## Wisconsin Department of Transportation

**Proposal #31: 6887-01-71**  
**T Larrabee, Buckbee Road**  
**S Br Pigeon River Bridge B-68-0151**  
**Local Street**  
**Waupaca County**

This is Addendum No. 01, which provides for the following:

Addendum No. 01  
ID 6887-01-71  
Revised Sheet 59  
January 2, 2026

NO.	DATE	REVISION	BY
1	12/15/25	ADDENDUM NO. 1	EJC
STATE OF WISCONSIN DEPARTMENT OF TRANSPORTATION			
STRUCTURE B-68-151			
CROSS SECTION, QUANTITIES, NOTES, & DETAILS			
SHEET 2			
59

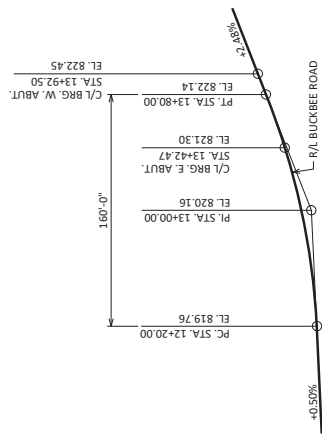
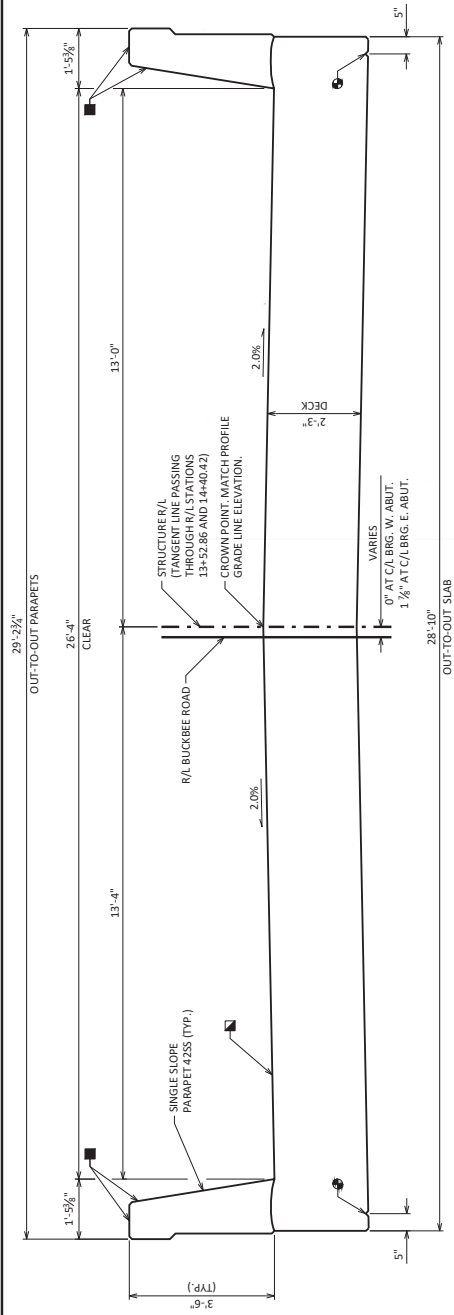
<b>Revised Plan Sheets</b>	
Plan Sheet	Plan Sheet Title (brief description of changes to sheet)
59	Cross Section, Quantities, Notes, & Details (Bid Item SPV.0180 Infill Riprap Station was deleted and Bid Item SPV.0195 Infill Riprap B-68151 was added)

612.0406	PIPE UNDERDRAIN WRAPPED 6-INCH	LF	95	97	---	192
645.0111	GEOTEXTILE TYPE OF SCHEDULE A	SY	21	21	---	42
645.0120	GEOTEXTILE TYPE HR	SY	133	136	---	269
8P/0.195	INFILL RIPRAP B-68-151	TON	25	27	---	52
NON-BID ITEMS						
NAME PLATE		EACH				1
FILLER		SIZE				1 1/2" & 3/4"
